Regarding: 06V-397

RECALL**This modification has top priority. This bulletin must be performed immediately to ensure customer safety.**

1999~2001 XV16 MODELS FACTORY MODIFICATION CAMPAIGN

Main Shaft Modification:

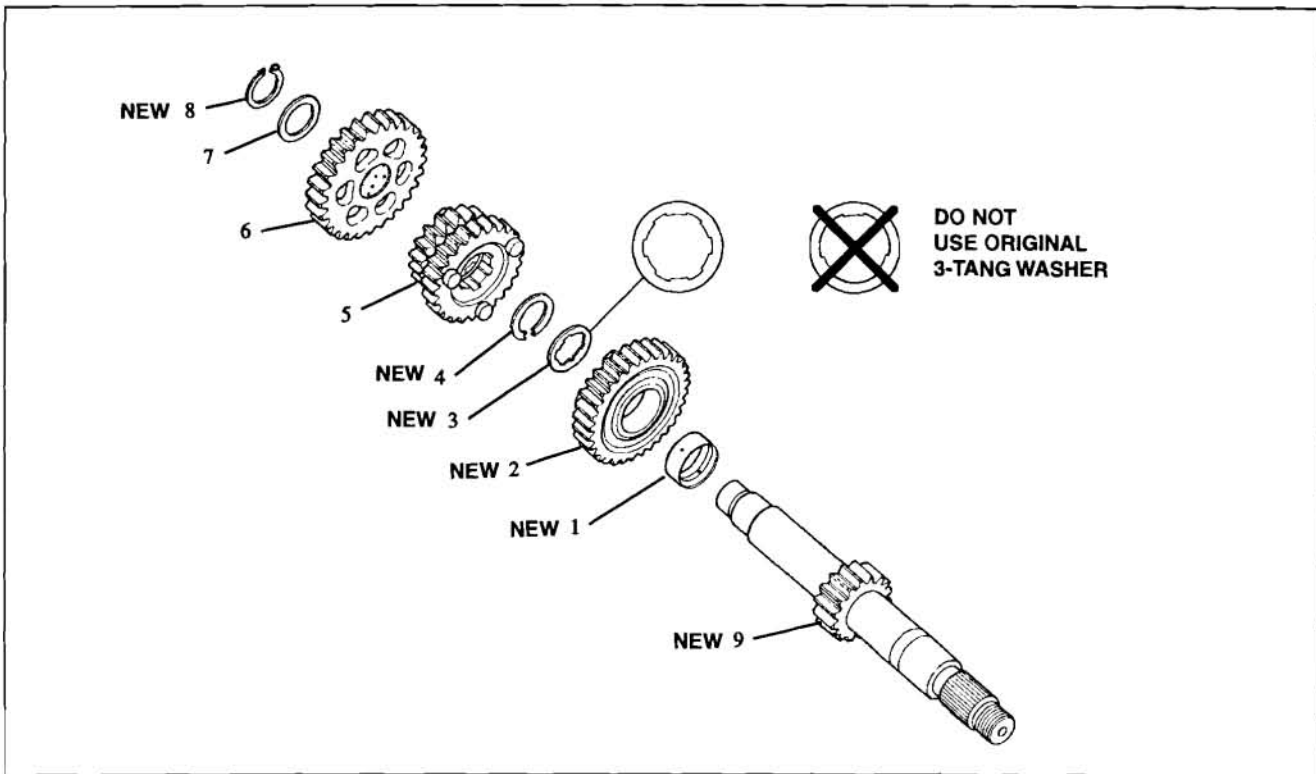
- Completely disassemble the main shaft. The Washer 7 , 5th Pinion Gear 6 , and 2nd/3rd Pinion Gear 5 will be reused.
- Install the components on the new-type Main Shaft 9 in the following order. Lubricate all components with engine oil. Be sure circlips are installed with the sharp edge of the inner diameter facing away from the mating washer.

- 1 Collar – NEW
- 2 4th Pinion Gear – NEW
- 3 Washer – NEW
- 4 Circlip – NEW
- 5 2nd/3rd Pinion Gear – Reuse original part
- 6 5th Pinion Gear – Reuse original part
- 7 Washer – Reuse original part
- 8 Circlip – NEW

Be sure to use all of the new parts in the kit. Otherwise, the transmission can still fail. Be sure that you are installing the new washer 3 . It is thicker than the original and can be easily identified by its six tangs on the inner diameter instead of the three on the original washer.

Drive Shaft Modification:

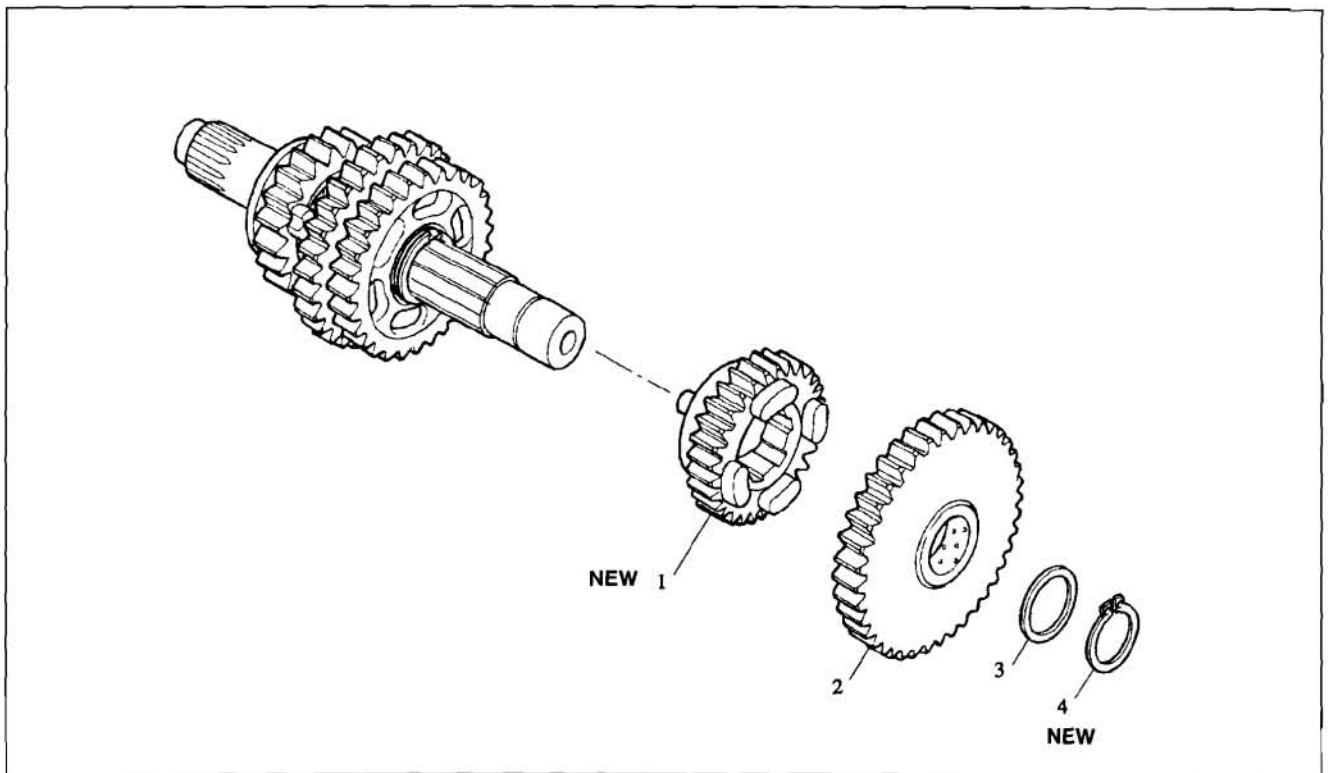
- Remove the circlip and washer from the Drive Shaft, then remove the 1st Wheel Gear and the 4th Wheel Gear. Do not disassemble the rest of the components on the shaft.
- Install the components on the original Drive Shaft in the following order. Lubricate all components with engine oil. Be sure the circlip is installed with the sharp edge of the inner diameter facing away from the mating washer.

- 1 4th Wheel Gear – NEW
- 2 1st Wheel Gear – Reuse original part
- 3 Washer – Reuse original part
- 4 Circlip – NEW

Be sure to use all of the new parts in the kit. Otherwise, the transmission can still fail.
